**BERGENFIELD ZONING BOARD OF ADJUSTMENT
REGULAR MEETING
TELECONFERENCE VIA ZOOM
February 1, 2021 8:00 PM**

Application: 145 West Main Street, LLC
145 West Main Street
Change of use to a multi-family dwelling R-5 zone to RM zone
Carried over from January 11, 2021 meeting.

SITE PLAN OF PROPOSED RESIDENTIAL BUILDING
LOT 6.01, 6.02 & 6.03 BLOCK 106 ZONE R-5

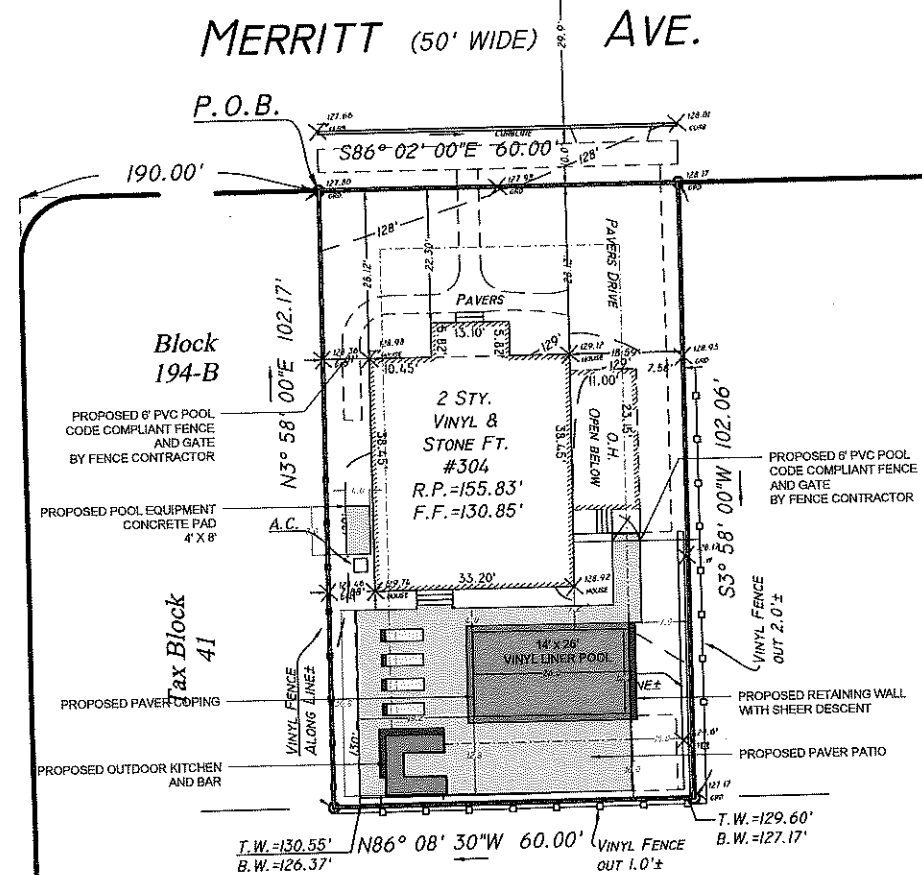
1. Improved lot coverage required 35% or 2,144.45 sq. feet. Proposed improved lot coverage 61.9% or 3,793.06 sq. feet with 10% bonus for brick pavers on driveway and pool patio included.
